DATE: August 18, 2011
TO: All Prospective Bidders

ADDENDUM NUMBER 2

CONTRACT NO. 60-11

**PRIMARY SEDIMENTATION AND
SLUDGE DIGESTION FACILITIES
AND
NEW LABORATORY, OPERATIONS BUILDING
AND ADMINISTRATION BUILDING RENOVATION**

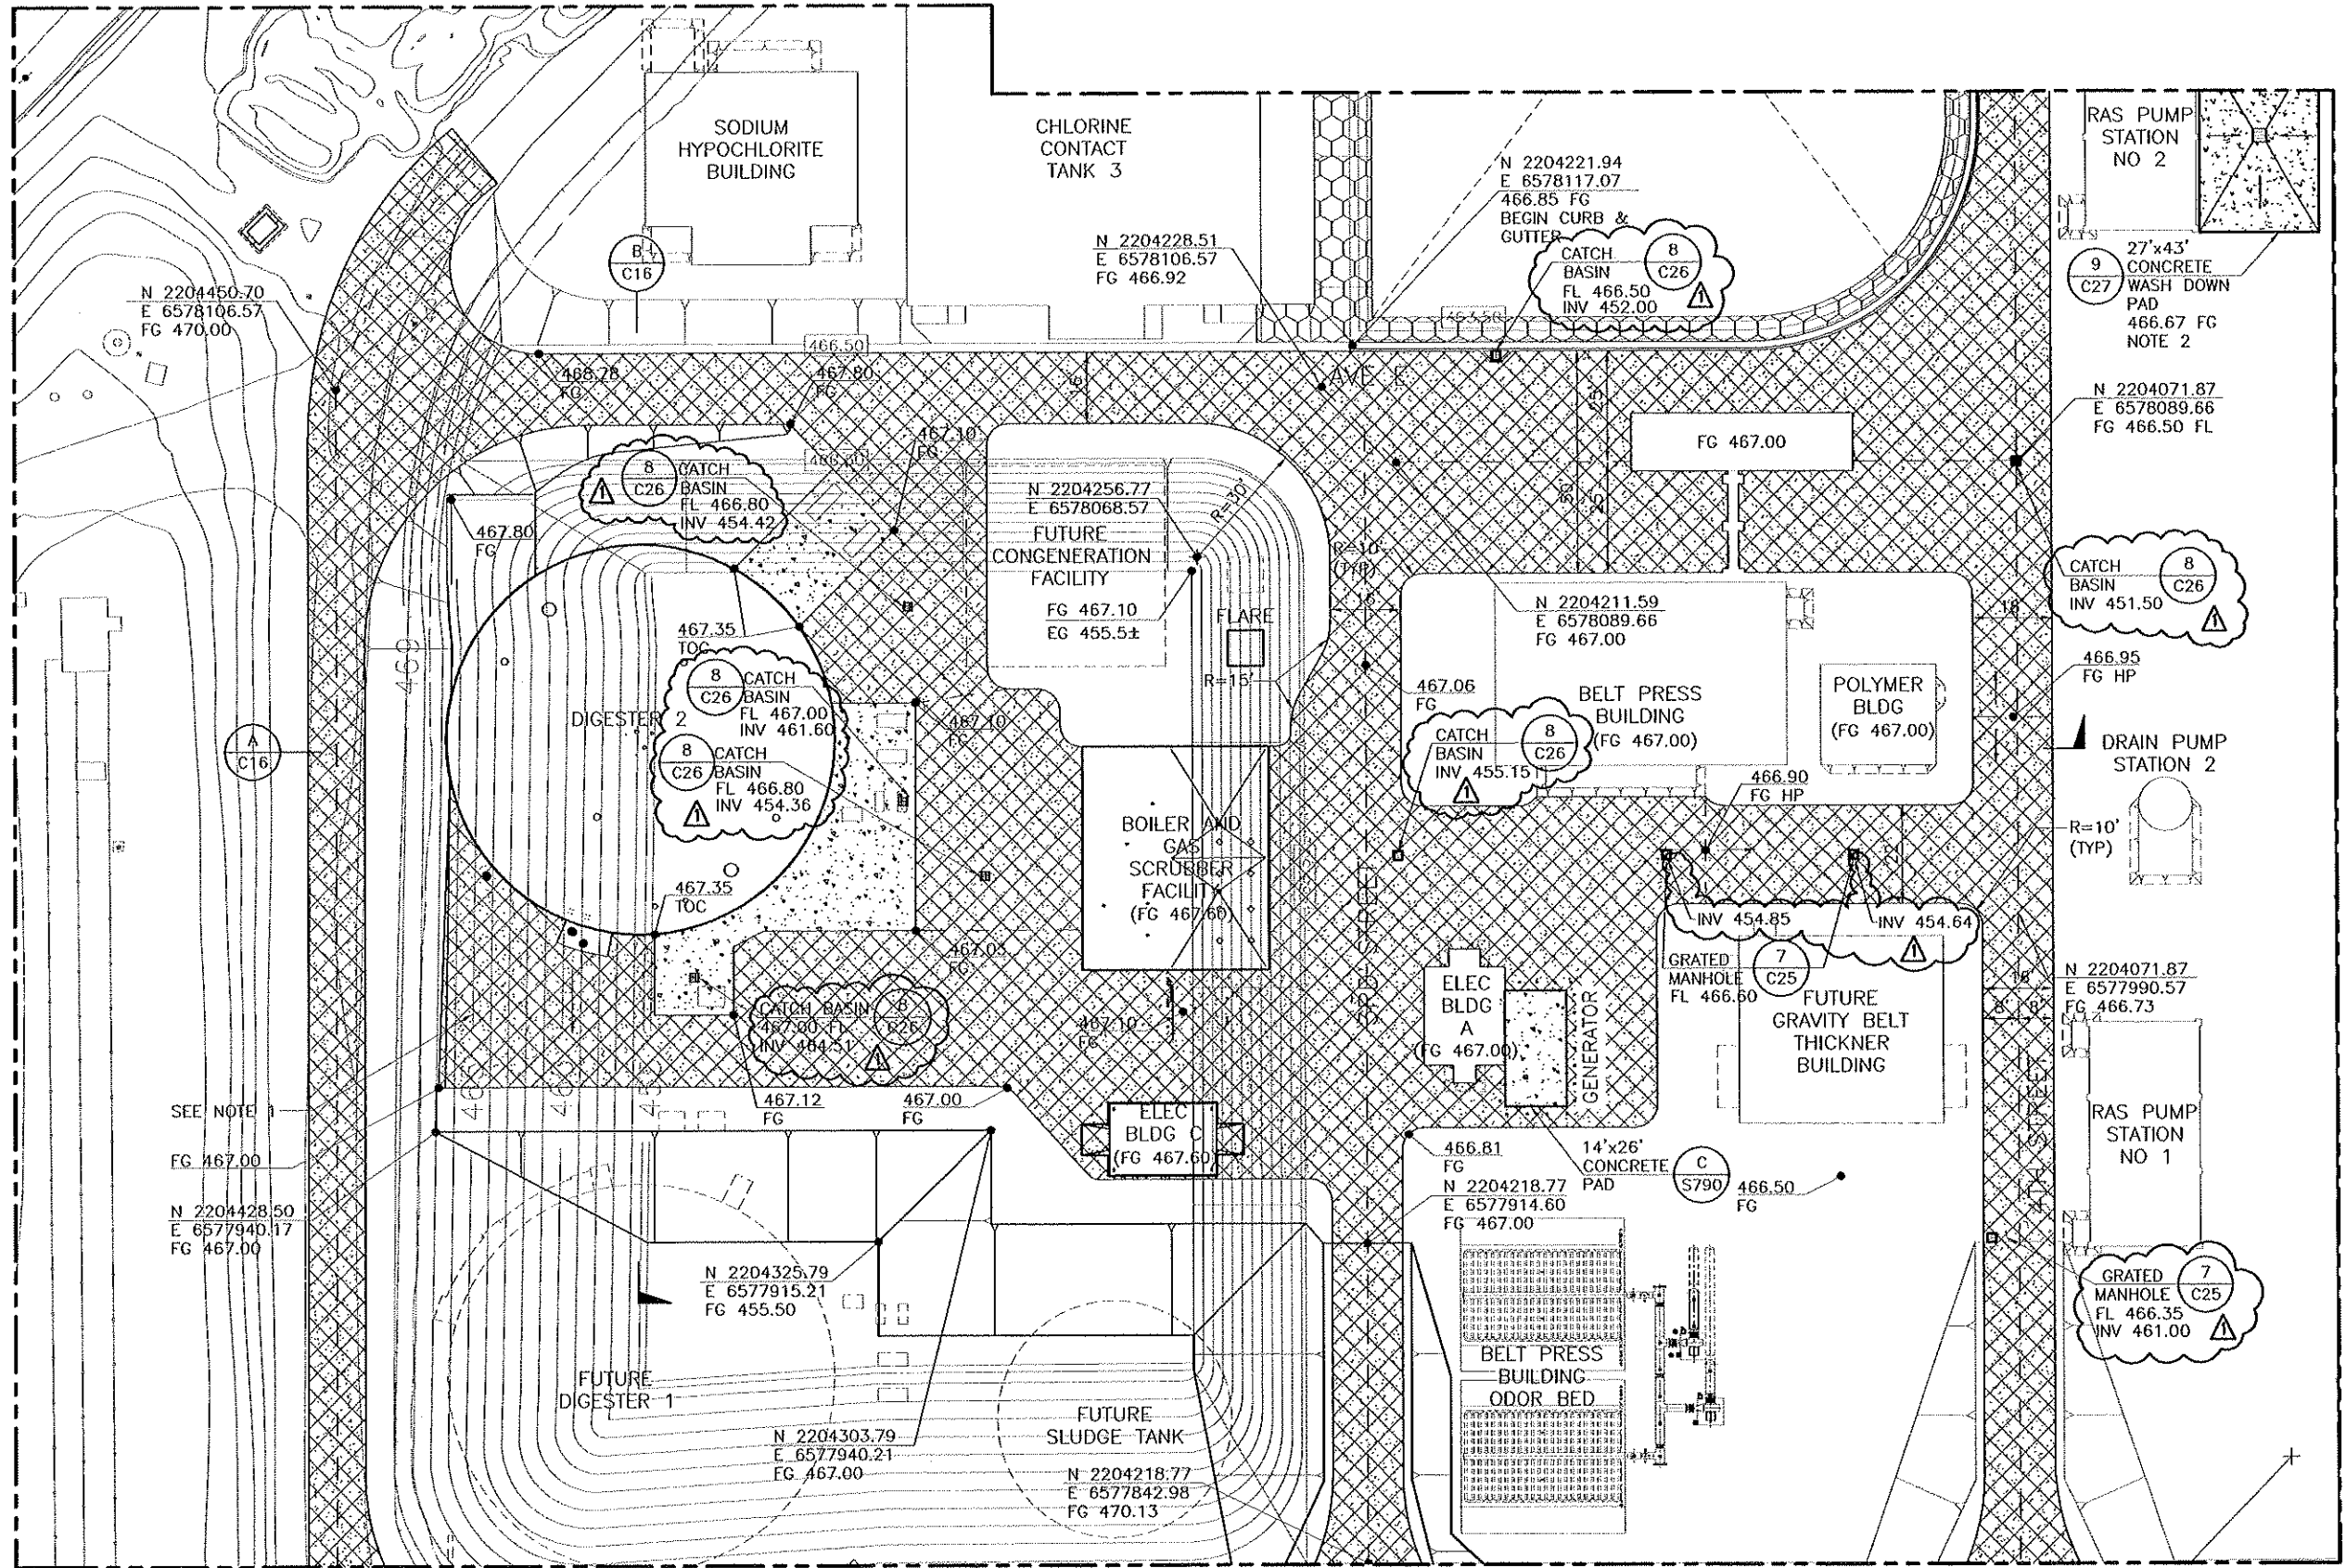
Existing elevations are shown on the Site Paving and Grading Plan sheets C12 and C14 but are not shown on sheets C13 and C15. Please provide existing elevations on sheets C13 and C15 so that accurate cut/fill quantities can be calculated.

Please provide Catch basin inverts (DTL 8 drawing 26) for catch basins found on drawing C13 .

See sections on Drawing C16 for existing elevations associated with grading on Drawing C13. The grading on Drawing C15 consists of drainage improvements (shotcrete, curbs, and paving) with the top of existing slope at approximate elevation of 466.50.

Drawing C13 will be reissued with catch basin invert elevations.

C111
SHEET
41
OF
230

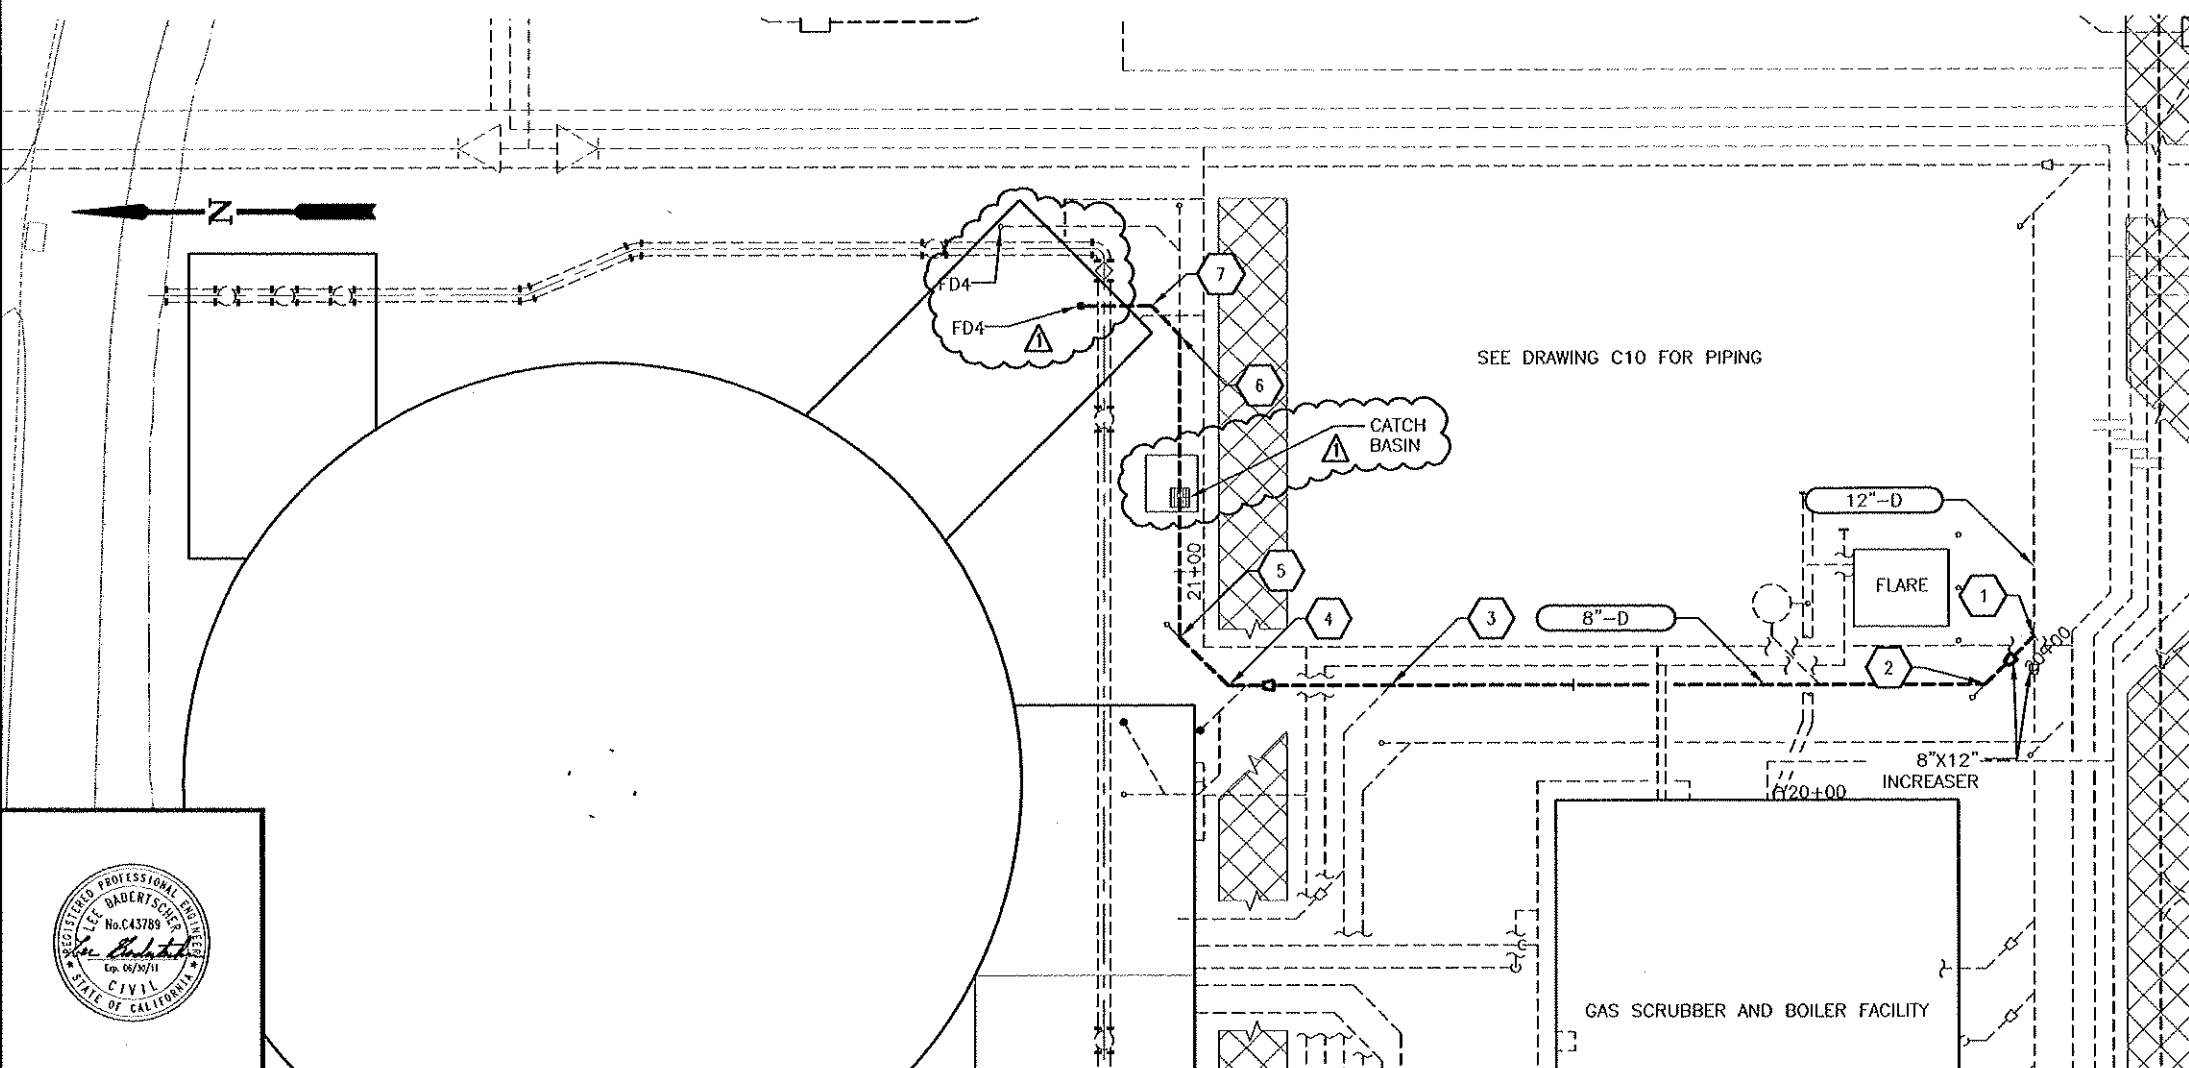
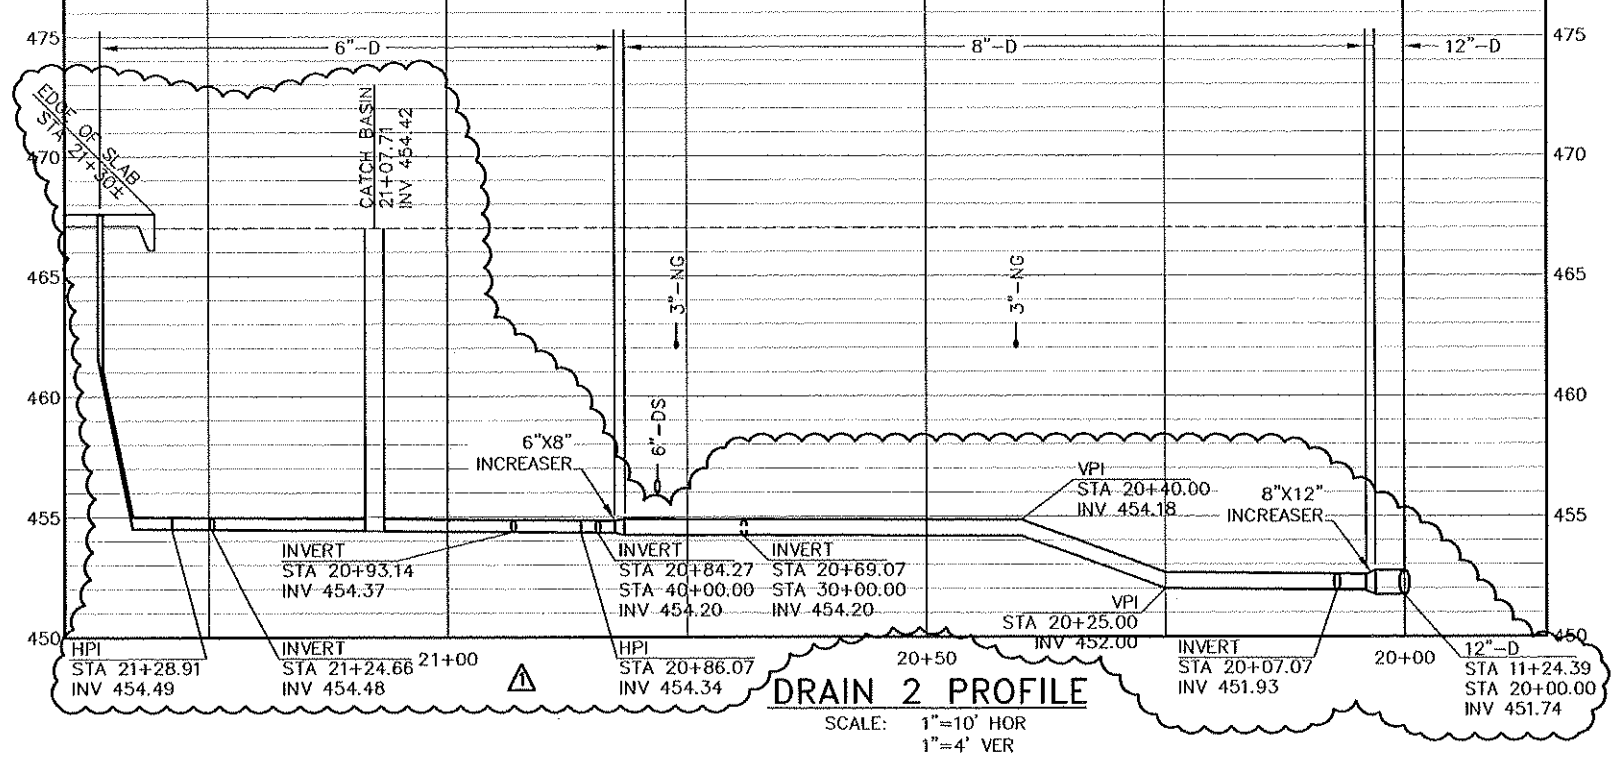
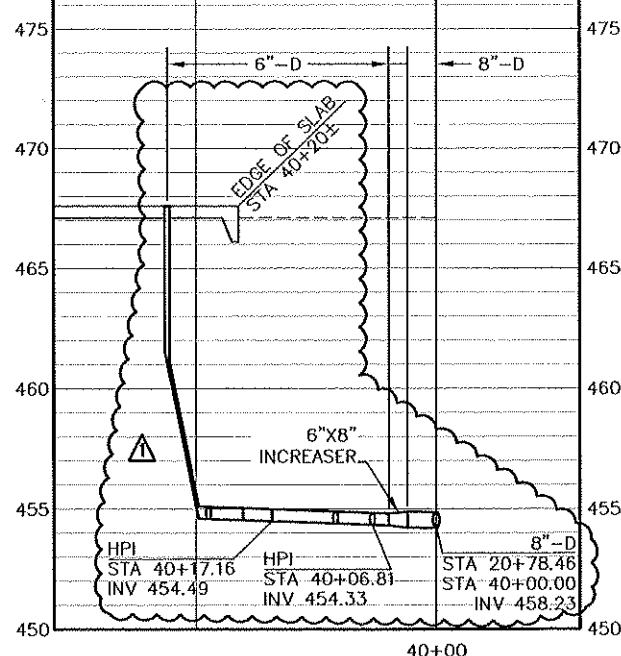
Drawing C111 calls out Drain 4 IE=454.22 at the tie-in to Drain 2 but drawing C113 calls out IE=458.23 for this same location. Please specify the correct invert elevation.

Drawing C10 and C11 callout TCO for D system piping. Drawing C110 callout is for either TCP (P) or TCO (P). Please specify the correct designation. As well, drawing C111 does not call out cleanouts.

Drawings M741 and C111 do not provide details on the terminations of Drain 4 lateral routing from the sludge mixing pump slabs. Please provide termination details.

The TCO is a Traffic Area Clean Out. The clean outs on Drawing C110 should read TCO(P), not TCP(P) and the clean outs on Drawing C111 should be TCO.
